General Nuclear System	REGULATORY OBSERVATION RESOLUTION PLAN RO-UKHPR1000-0029	Rev.: 0	Page: 1 / 10
		GDA-REC-GNSL-006047

REGULATORY OBSERVATION Resolution Plan

RO Unique No.:	RO-UKHPR1000-0029
RO Title:	Internal Fire PSA
Technical Area(s)	PSA
Revision:	0
Overall RO Closure Date (Planned):	2021-04-30
Linked RQ(s)	RQ-UKHPR1000-0015/RQ-UKHPR1000-0466/RQ-UKHPR1000-0467
Linked RO(s)	
Related Technical Area(s)	Internal Hazards
Other Related Documentation

F-1 General Procedure of Multi-compartment Analysis

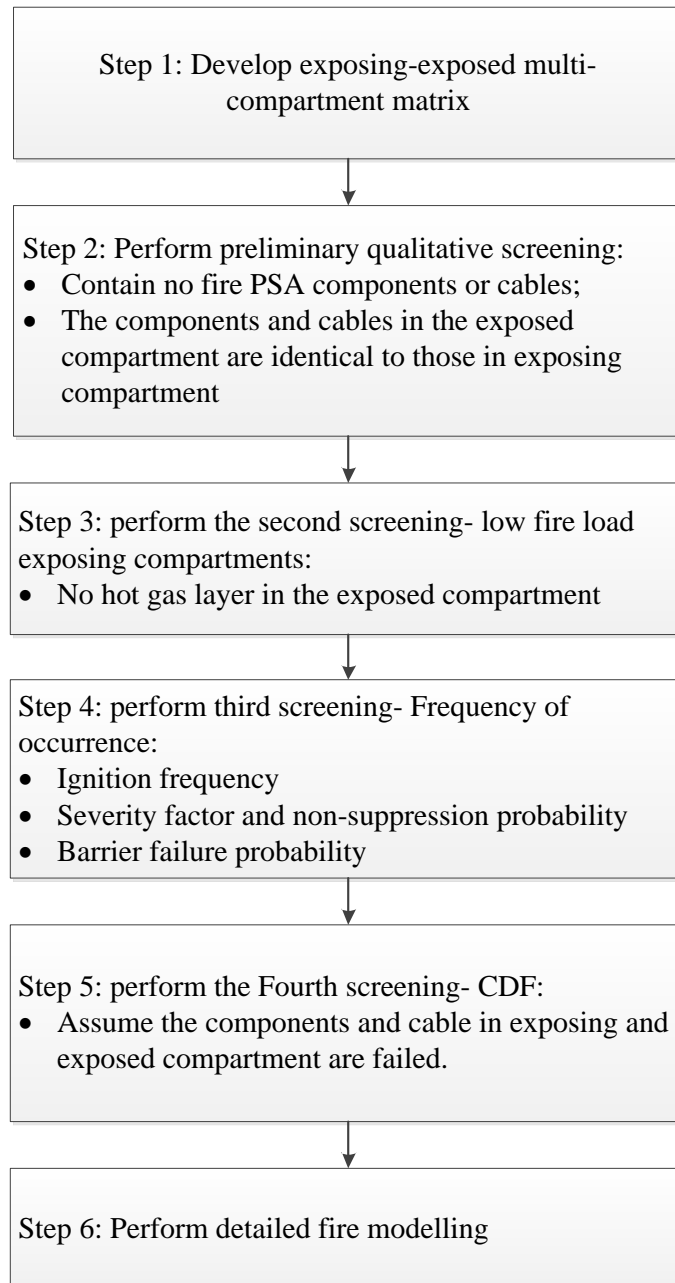
General Nuclear System Limited should demonstrate that MCA scenarios have been considered in the internal fire PSA. This may be addressed by updating the extant internal fire PSA, or by issuing a new separate report during GDA timescales.

- *Show evidence that MCA has been performed in accordance with NUREG/CR-6850 guidance Section 11.5.3 and quantitatively evaluate the risk.*
- *The interfacing barriers between fire compartments need to be reviewed and barrier feature need to be counted in order to determine a barrier failure probability, this should include consideration for random barrier failure.*

The multi-compartment analysis will be performed in the updated *Internal Fire Level 1 PSA* report to be submitted in December 2020. The general procedure of multi-compartment analysis is shown in F-1 according to NUREG/CR-6850 (Ref.5) and is described as follows:

- 1) To develop an exposing-exposed multicompartment matrix.
- 2) To perform preliminary qualitative screening. The corresponding exposing-exposed multicompartment is screened out if:

- ✓ The exposed compartments contain no fire PSA components or cables, or
 - ✓ The components and cables in the exposed compartment are identical to those in the exposing compartment.

- 3) To perform secondary screening. If the fire load in exposing compartment is so low that no hot gas layer is generated in the exposed compartment, the corresponding exposing-exposed multicompartment can be screened out. In this step, the recommended 98% percentile of the Heat Release Rate (HRR) probability distribution will be used which provides conservative results.

- 4) To perform the third screening. The scenario frequency is calculated by multiplying ignition frequency, combined severity factor and non-suppression probability and barrier failure probability. The barrier failure probabilities are from NUREG/CR-6850 (Ref.5).

- 5) To perform the fourth screening. In this step, it is assumed that all the fire PSA components and

cables in exposing and exposed compartments are failed, and then a conservative CDF is calculated.

6) To performed detailed fire modelling. The scenarios that are not screened out in the preceding steps are analysed using the same method as single compartment.

F-2 General Procedure of Detailed Circuit Failure Analysis

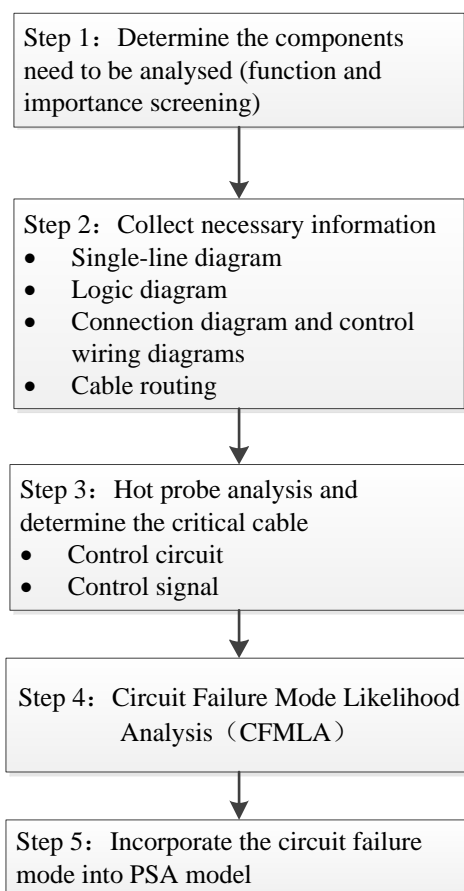
General Nuclear System Limited should demonstrate that multiple spurious operations due to fires at 'pinch-points' in the design have been included in the internal fire PSA. This may be addressed by updating the extant internal fire PSA, or by issuing a new separate report during GDA timescales.

- *Evidence needs to be presented that a systematic process has been exercised to identify fire*

scenarios which could lead to multiple spurious operations. The resulting consequences need to be incorporated in the PSA model, along with appropriate fire frequency estimation.

The detailed circuit failure analysis will be performed with the the cable routing information based on FCG3 in the updated *Internal Fire Level 1 PSA* report to be submitted in December 2020. The general procedure of detailed circuit failure analysis is shown in F-2.

Based on above methodology, for one fire compartment, the scenarios of spurious operations of different components are identified. For Multiple Spurious Operation (MSO), the FAQ 07-0038 (Ref. 6) and the generic MSO list from NEI 00-01(Ref. 7) will be taken as reference. Other scenarios which are not included in the generic MSO list will be determined from P&ID, cutset or sequences.
